**Committee of Experts on the Transport of Dangerous Goods
and on the Globally Harmonized System of Classification
and Labelling of Chemicals****Sub-Committee of Experts on the Transport
of Dangerous Goods****Thirty-eight session**

**Updating of the third revised edition of the Globally
Harmonized System of Classification and Labelling of
Chemicals (GHS): Physical hazards****Determination of chemical instability of gases****Transmitted by the expert from Germany on behalf of the informal
working group¹****Introduction**

Proposed amendments to the Manual of Tests and Criteria

Figure 3x.1: Test apparatus

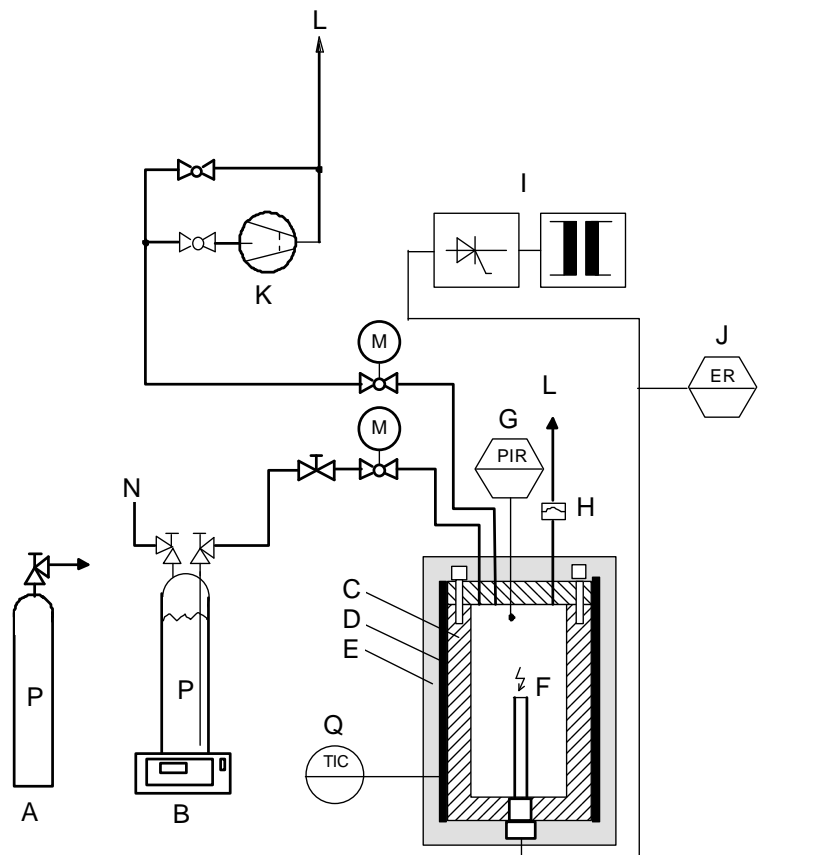
3x.4.2.1 The test apparatus (see Figure 3x.1) consist of a pressure resistant test vessel (heatable) made of stainless steel; an ignition source; a measuring and recording system to record the pressure inside the ignition vessel; a gas supply; a venting system with bursting disk and additional piping, fitted with remote-controlled valves and cocks.

The test vessel is a cylindrical stainless steel vessel with an inner volume of about 1 dm³ and an inner diameter of 80 mm. An exploding wire ignition source is screwed into the bottom of the vessel. The vessel is equipped with a heating jacket which is connected to a temperature control unit that heats the outer vessel wall with an accuracy of ± 2 K. The test vessel is insulated with temperature resistant insulation material to avoid heat loss and temperature gradients. The test vessel shall be pressure resistant up to 500 bar (50 MPa).

The ignition source is an exploding (fusing) wire igniter similar to that described in ASTM E 918 and EN 1839. The igniter consists of two insulated electrodes at 3 mm to 6 mm distance, holding a nickeline wire of 0.12 mm diameter at its ends. The ignition energy is provided by a 1.5 kVA/230 (115) V insulating transformer, which is switched for a short time period to this igniter. The wire melts and then an electrical arc burns between the electrodes for a period extending in maximum to half a period of the supply voltage (10 (8.3) ms). An electronic control unit allows switching different time periods of the mains voltage half wave to the igniter. The corresponding energy delivered shall be in the range of $15 \text{ J} \pm 3 \text{ J}$. The energy can be measured by recording the current and voltage during ignition.

The bursting disk is supposed to protect the test vessel. It is connected to a vent pipe for the exhaust gas. The free diameter of the bursting disk should be at least 10 mm, the inner diameter of the pipe at least 15 mm. The opening pressure of the bursting disk shall amount to 250 bar (25 MPa).

The piping and valves which are fitted directly to the test vessel, shall be pressure resistant up to 500 bar (50 MPa). The test apparatus shall be operated by remotely operated valves.
